NOTICE OF MOTION NUMBER: 36

Item: 7.1 **Ref:** WO/2023/02763
Title: Supplementary Submission on Winterbourne Wind Project Amendment Report
Author: Councillor McCoy
Attachment: No.

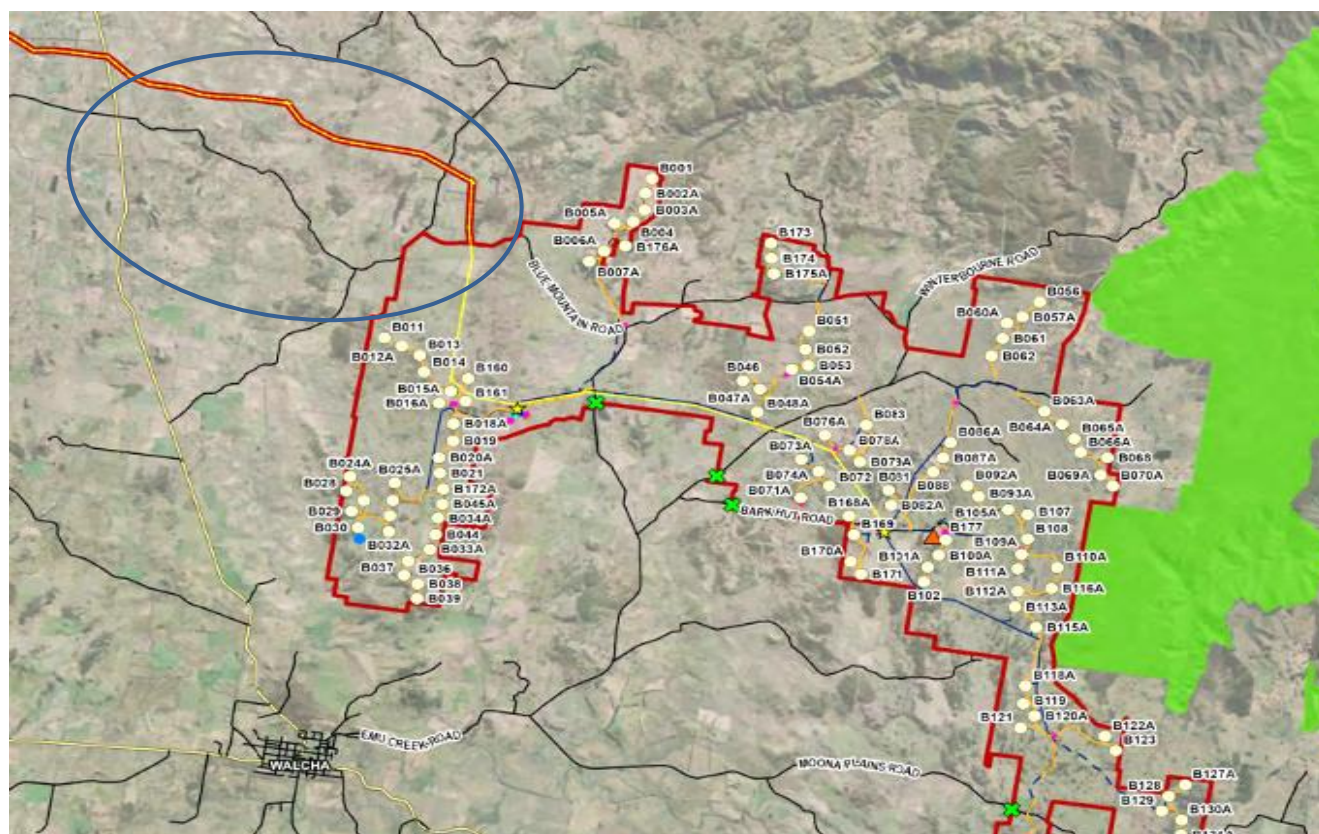
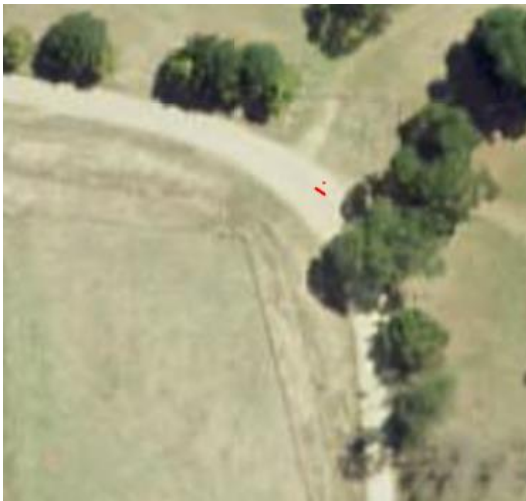
On Thunderbolts Way, 22.3km North of Walcha, the southbound lane, has a left turn into Hillview Road.

Hillview Road, from Thunderbolts Way to the Mirani Road intersection is 9.6km. This section of road for the most part, is already between 5m and 6m wide and is well constructed from good all-weather gravel. It passes 6 homes that are set well back from the road (75m to 320m)

Chainage	Image	Comment
0.6km		<p>The first bend from Hillview Rd turnoff.</p> <p>There is no vegetation on this side of the road. These are the only trees in the vicinity. Prior to this there is open, unvegetated farmland.</p>
0.6km		<p>Out from the above corner is a house. At a setback of 75m from the road, it is the closest of all the houses.</p> <p>A 300m section of road would need to be sealed to reduce dust</p>
0.8km		<p>This is followed by a second house set back 200m from the road. Again, dust suppression would be needed</p>

1.6km		<p>There is a stand of small to medium scrub with 1 or 2 larger trees. Many of the smaller trees are dead. The stand of trees goes for about 500m, much of it off to the side of the road.</p> <p>The road at this point is narrow and would need widening</p>
2.3km		<p>At the end of the above stand of trees, is a Telstra access road turnoff to the left, with a standard overhead powerline.</p>
2.7km		<p>The road widens out to about 6m.</p> <p>There is a third house which is set back 185m from the road, and a well-treed road reserve. The occasional limb overhangs the road. Dust suppression would be needed.</p>
3.3km		<p>There is a slight hollow, with some deciduous trees.</p>

3.6km		<p>The whole road has a good all-weather gravel base with flat to small rolling land.</p> <p>The road narrows to about 5m and becomes clear and open.</p>
4.0km		<p>Location of the fourth house, set back 320m from the road.</p>
4.8km		<p>A slight bend leading into a bigger bend with a culvert. The bends are sweeping but the narrow culvert would need widening.</p>
5.45km		<p>The road then crosses a causeway and cattle grid and moves through unfenced land with a slightly wider than 5m pavement.</p> <p>Replacing the grid with a wider grid or fencing the road reserve should be considered.</p>

<p>For the next 4km the road widens out to about 6m again and crosses 3 more cattle grids.</p> <p>There is one corner that has a bend/cattle grid/tree combination that may need improvement.</p> <p>There is also the fifth house which is 180m from the road.</p>
9.6km		<p>The road passes the Mirani private road turnoff and a house 140m from the road.</p>

A connection to the WWF private road would be made a further 1.4km along Hillview Road at the location where the proposed WWF transmission intersects the road.

- 1. using Hillview Road for all light and heavy vehicle access to the development; and**
- 2. lowering the height of the 8 to 20 turbines located within a 10km radius of Walcha**

The attached image is from the original project layout, with the distance rings being:

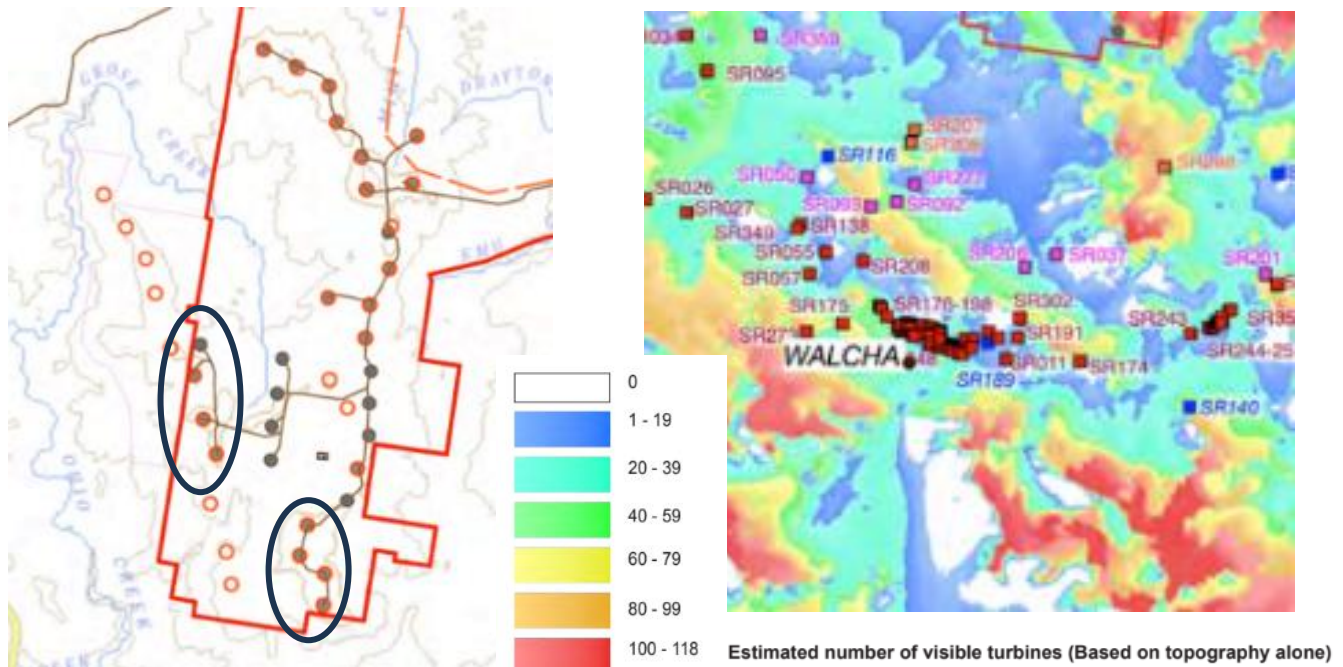
It should also be noted that the distance of 6.5km was measured from the centre of town, which means the first turbine location reduces to a distance of approximately 5 km from residents on the northern edge of town.

Note that turbines A 031, A032, A033 and A034 have been relocated at a further distance in the amended proposal.

An improvement to the visual amenity of the project could be to revisit the factors (listed previously) that were believed to improve visual amenity. Specifically, the belief that the height of the turbines needs to be the same to be pleasing to the eye. Generally, this is true, but the current layout of the turbines may

lend itself to lowering the height of the turbines closest to Walcha and that are most likely to have an impact on its visual amenity.
